## **ADDENDA NO. 1**

**PROJECT NAME:** York General Assisted Living Facility – Willowbrook Assisted Living Addition  
**ARCHITECT'S PROJECT NUMBER:** 13-118

**DATE OF ISSUANCE:** January 31, 2014  
**DATE OF BID OPENING:** February 6, 2014

# ADDENDUM

**DRAWING No. A1.4 – Unit Floor Plans**

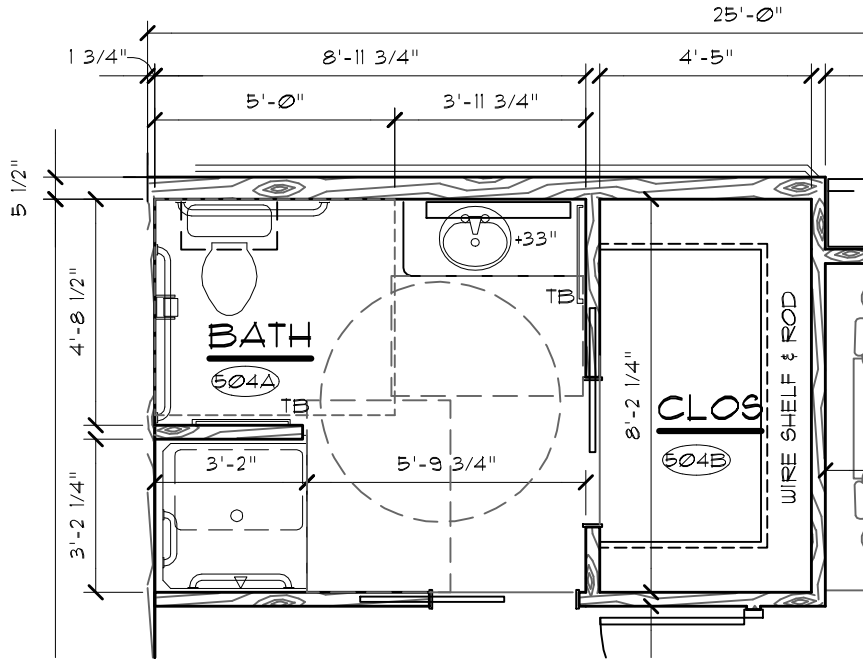
1. At Plan Detail 2 – Type A-1X Bedroom ADA, revise the shower orientation at Bath 504A as shown on the attached plan detail.
2. At Plan Detail 3 – Type A-2X Bedroom ADA, revise the shower orientation at Bath 509G as shown on the attached plan detail.
3. At Plan Detail 5 – Type B-1X Bedroom ADA, revise the shower orientation at Bath 506A and add a 3 1/2" wood stud chase at the pocket door side of the shower as shown on the attached plan detail.
4. At Plan Detail 1 – At Kitchen/Dining 501C, revise the casework elevation from detail 8, sheet A7.1 to detail 6, sheet A7.1.

**TYPE A - 1X**  
**1 BEDROOM (ADA)**

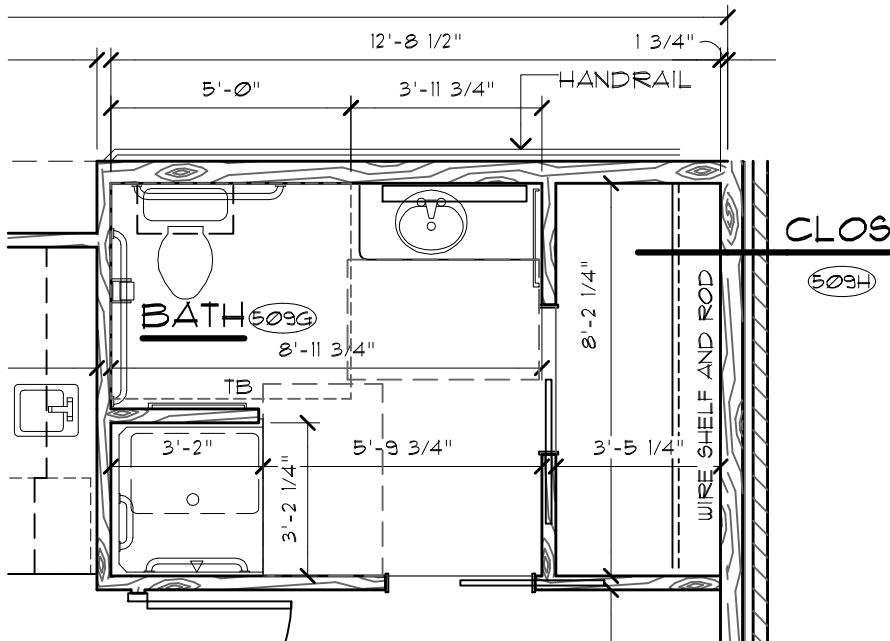
FLIP SHOWER SEAT AND PLUMBING (ROTATE SHOWER)

**TYPE A-2X**  
**1 BEDROOM (ADA)**

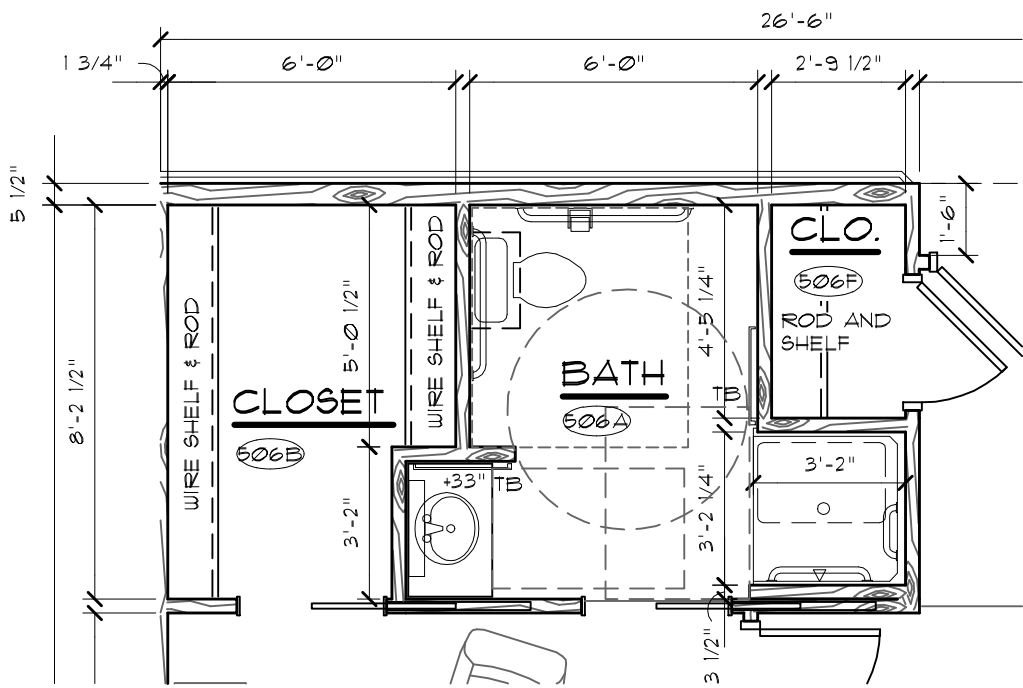
FLIP SHOWER SEAT AND PLUMBING (ROTATE SHOWER)

**MO.1**

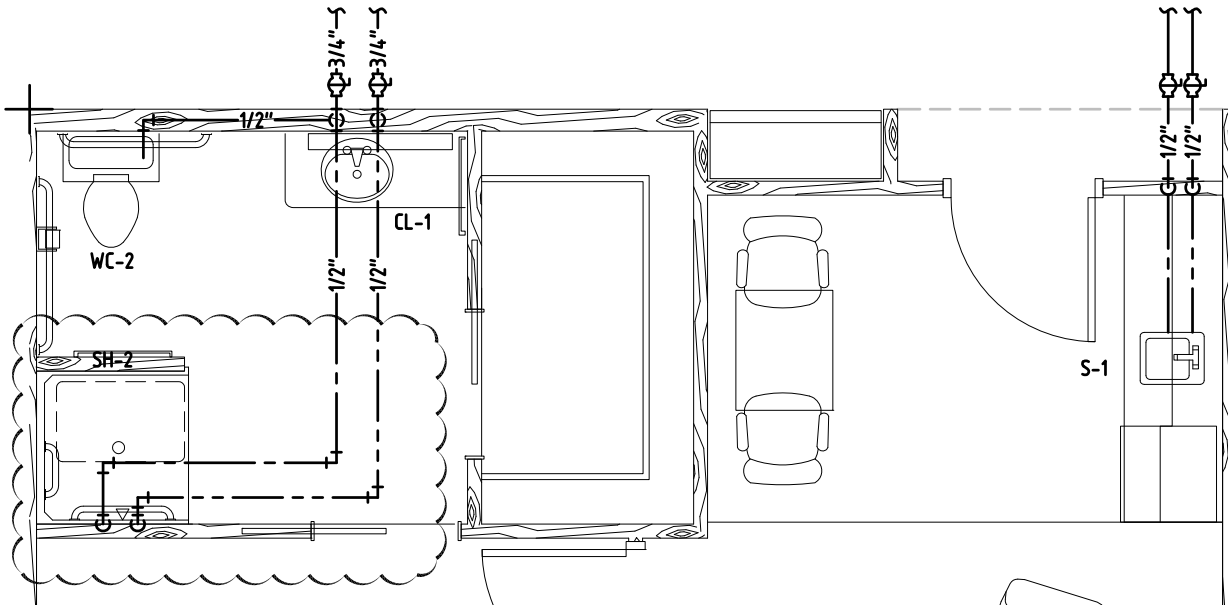
**Mechanical****1. Sheet M0.1****A. General notes: Include the following note**

- 1) Rework of the well field header piping shall be done prior to flush and purge at the beginning of September when the weather is favorable for a complete system shut down. Down times shall be coordinated with the owner / PM prior to installation with down times kept to a minimum. As much work shall be done ahead of time to facilitate a short shut down. The Mechanical contractor shall be responsible for coordination. The adjacent wall shall be partially removed ahead of time to allow for the re-piping, the wall will then need to be re-installed and finished to match existing. The well field contractor shall be responsible to cut the header and connect 2 flanges to the existing 6" HDPE header, he shall be on-site to perform work the day of the shutdown. The mechanical contractor is responsible for all other work associated with the rework of the well field header piping.

REWORK OF THE WELL FIELD HEADER PIPING SHALL BE DONE PRIOR TO FLUSH AND PURGE AT THE BEGINNING OF SEPTEMBER WHEN THE WEATHER IS FAVORABLE FOR A COMPLETE SYSTEM SHUT DOWN. DOWN TIMES SHALL BE COORDINATED WITH THE OWNER / PM PRIOR TO INSTALLATION WITH DOWN TIMES KEPT TO A MINIMUM. AS MUCH WORK SHALL BE DONE AHEAD OF TIME TO FACILITATE A SHORT SHUT DOWN. THE MECHANICAL CONTRACTOR SHALL BE RESPONSIBLE FOR COORDINATION. THE ADJACENT WALL SHALL BE PARTIALLY REMOVED AHEAD OF TIME TO ALLOW FOR THE RE-PIPING, THE WALL WILL THEN NEED TO BE RE-INSTALLED AND FINISHED TO MATCH EXISTING. THE WELL FIELD CONTRACTOR SHALL BE RESPONSIBLE TO CUT THE HEADER AND CONNECT 2 FLANGES TO THE EXISTING 6" HDPE HEADER, HE SHALL BE ON-SITE TO PERFORM WORK THE DAY OF THE SHUTDOWN. THE MECHANICAL CONTRACTOR IS RESPONSIBLE FOR ALL OTHER WORK ASSOCIATED WITH THE REWORK OF THE WELL FIELD PIPING.

**M1.1**

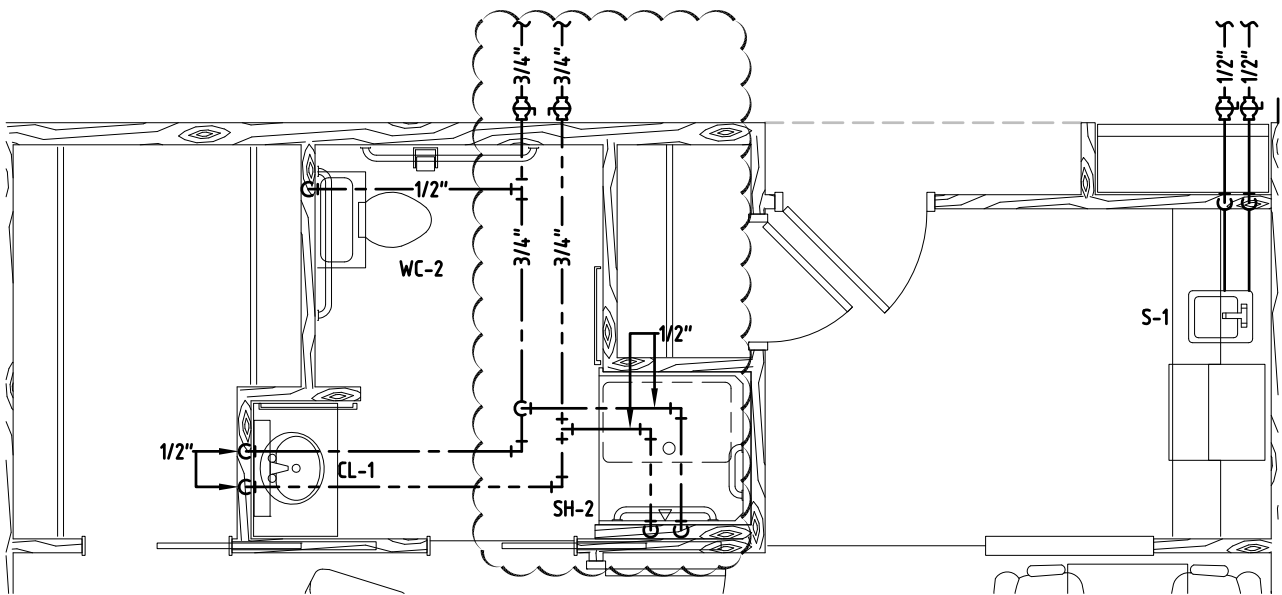
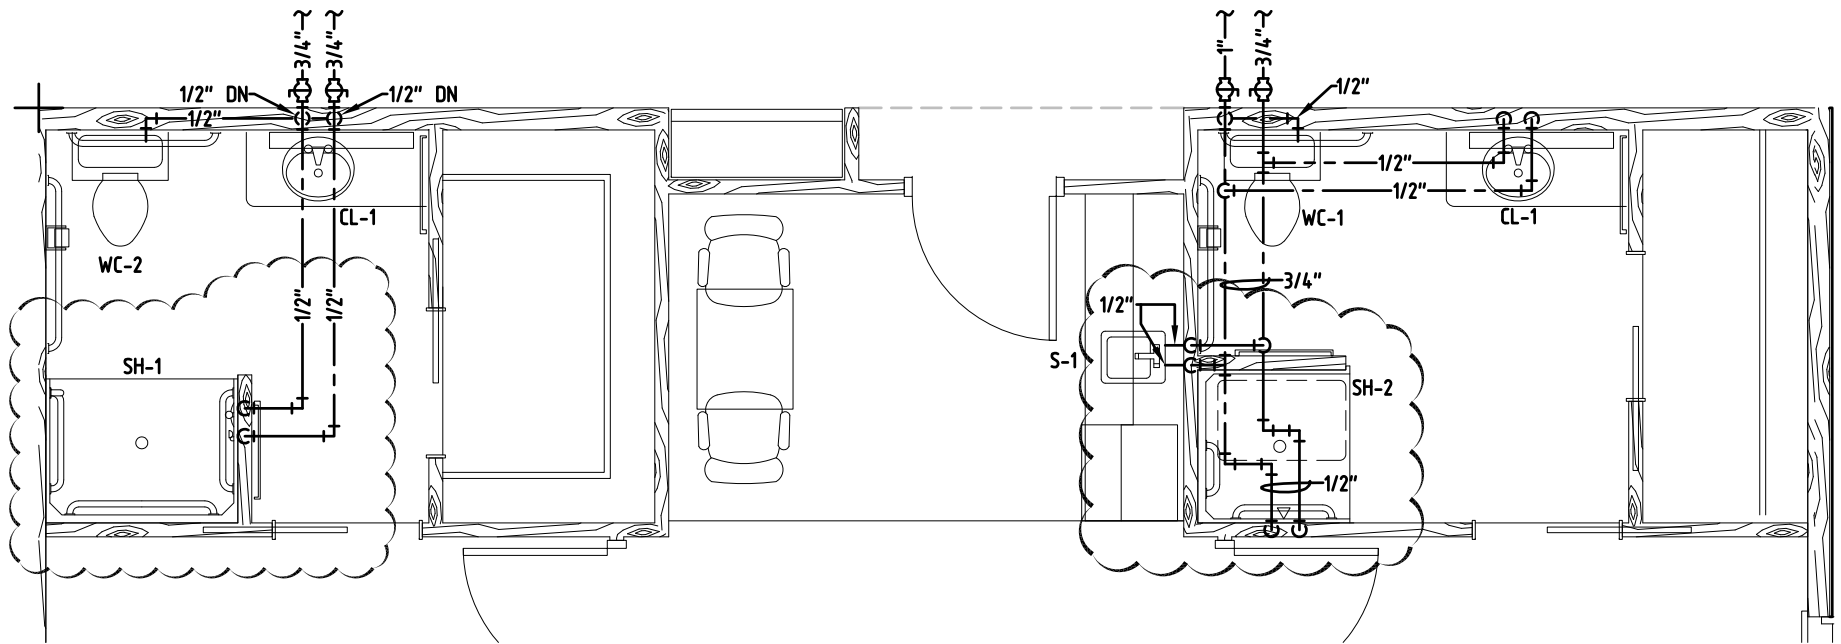
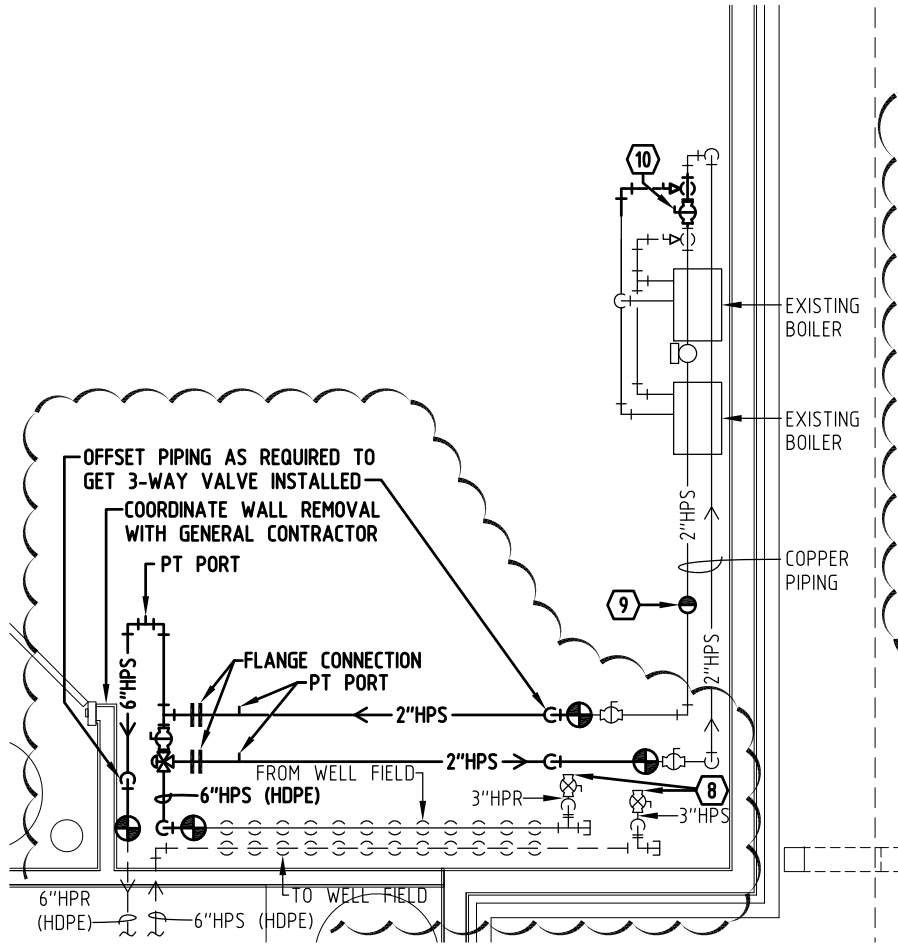
**2. Sheet M1.1****A. ADA units Type A-1X, A-2X, B-1X**

- 1) Revised domestic water piping routing to showers. See attached drawings.

# M3.0

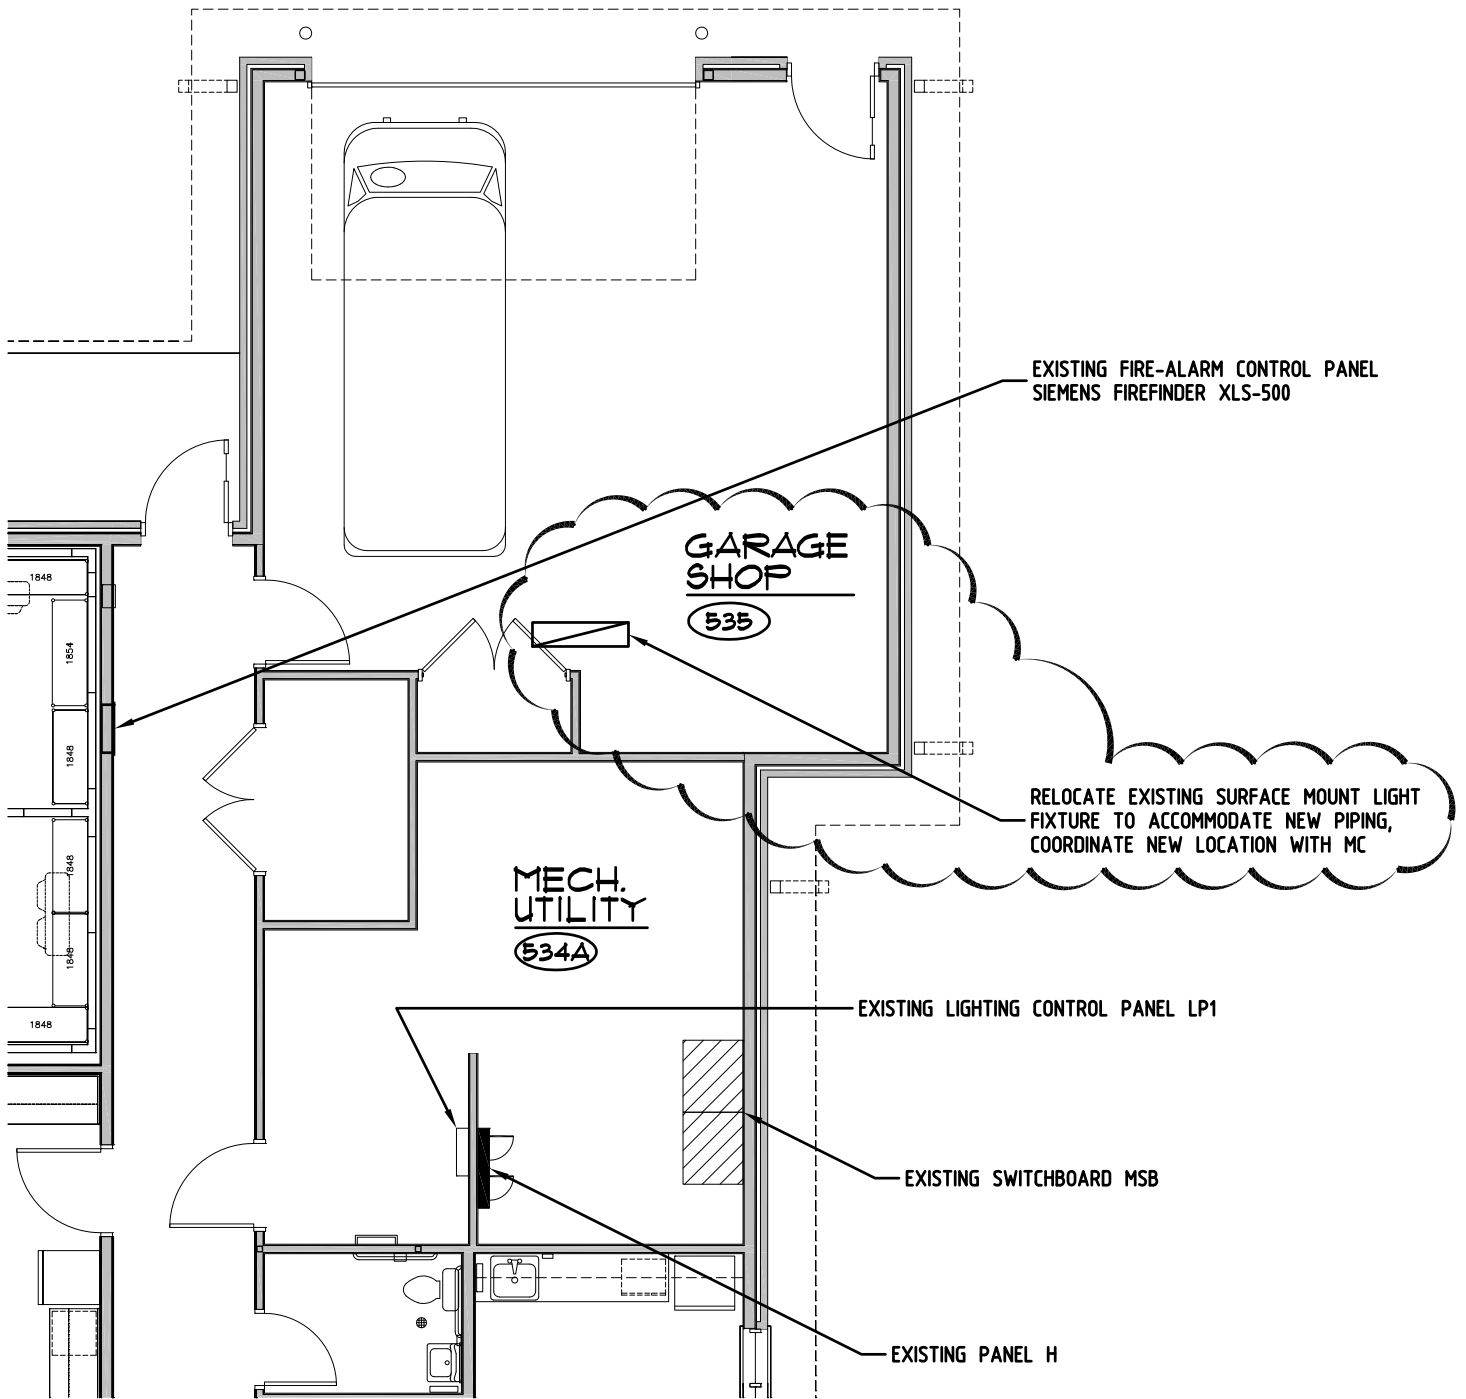
**4. Sheet M3.0****A. Shower (SH-2)**

- 1) Unit #model number shall be LCS4038A5T and coordinate required 8"x8" block outs with GC prior to floor installation. See shower drain detail added via this addendum.

**B. Waste and Vent Riser**

- 1) Add note: Vent piping is to be installed in the attic space adjacent to the mezzanine. Piping is allowed in mezzanine if coordinated with other systems.

**E. Flushing and purging specifications and procedures**

- 1) The last line of text shall read "The existing system has approximately 6244 gallons of water, 57 heat pumps with the heat pumps piped each with a strainer and no valved bypass. There are check valves installed above the existing heat pump loop pumps."

- ALL WASTE & VENT UNDERGROUND PIPING TO BE A MINIMUM OF 2".
- SLOPE ALL PIPING A MINIMUM OF 1/8" PER FOOT AND MORE IF SPECIFICALLY NOTED.
- 1-1/2" VENT PIPING SHALL NOT EXCEED A HORIZONTAL LENGTH OF 20'.
- ALL PIPING TO CLEAN OUTS TO BE 4". WALL MOUNTED CLEAN OUTS TO BE INSTALLED 2" - 6" ABOVE FLOOD RIM OF ADJACENT FIXTURES.
- VENT PIPING IS TO BE INSTALLED IN THE ATTIC SPACE ADJACENT TO THE MEZZANINE. PIPING IS ALLOWED IN MEZZANINE IF COORDINATED WITH OTHER SYSTEMS.

THE EXISTING SYSTEM HAS APPROXIMATELY 6244 GALLONS OF WATER, 57 HEAT PUMPS WITH THE HEAT PUMPS PIPED EACH WITH A STRAINER AND NO VALVED BYPASS. THERE ARE CHECK VALVES INSTALLED ABOVE THE EXISTING HEAT PUMP LOOP PUMPS.
